Alfa Patterns (BD) Ltd.

58, DEPZ (Old) Ganakbari, Savar, Dhaka
(+23.94936667N, 90.26815E)

01 October 2013

Building Observations

Slab Penetrations

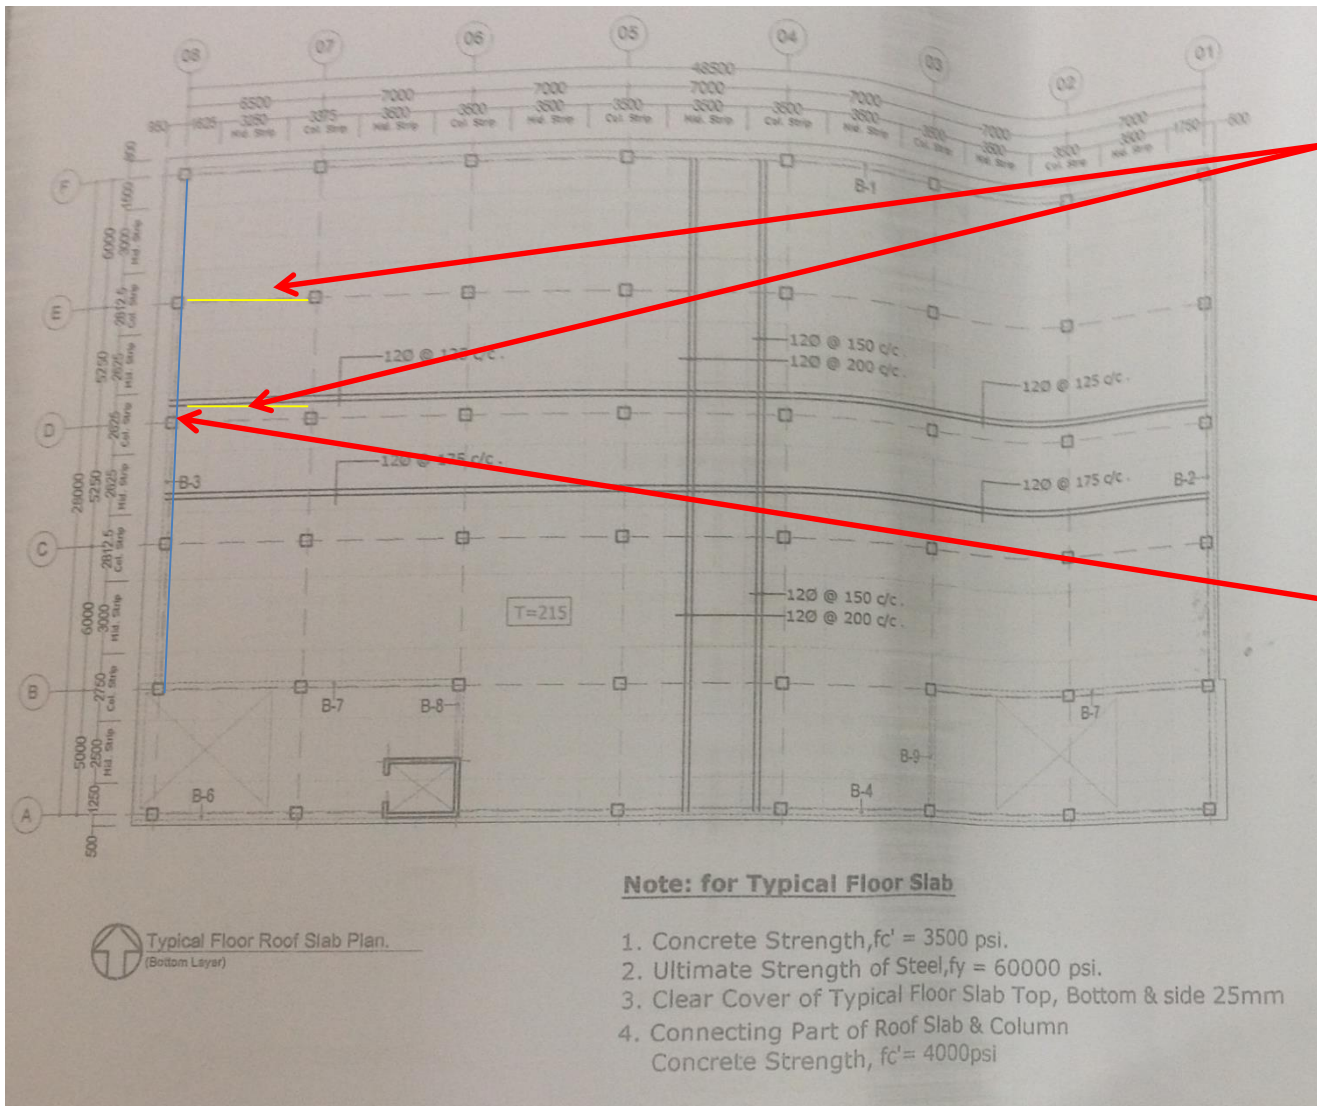
Slab penetrations through 2nd floor for new bathroom drain pipes near column

**New slab penetrations.
Verify that slab edge
beams are designed to
trim openings**

1st Floor – Perimeter Beams

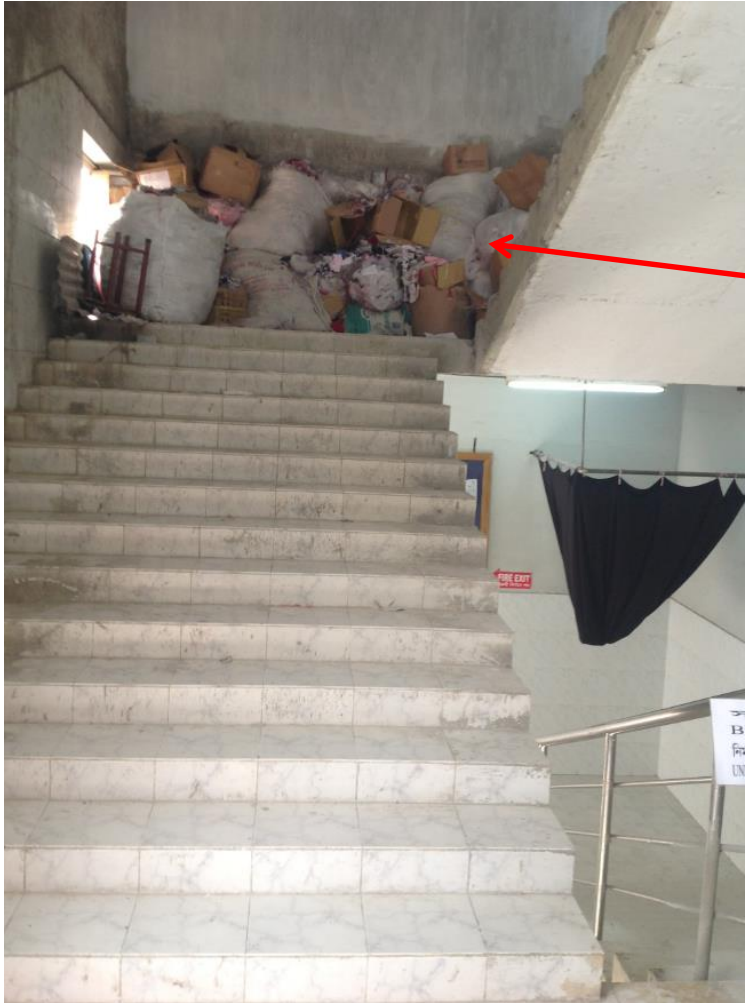
Review 1st floor structure at gridline F/8 to D/8 and confirm that beams provided are in accordance with design

**Are beams missing on
grid F/8 to D/8**

Beams as constructed and not shown on drawing

Are beams missing on grid F/8 to D/8.

Drawing provided shows beam at this location.
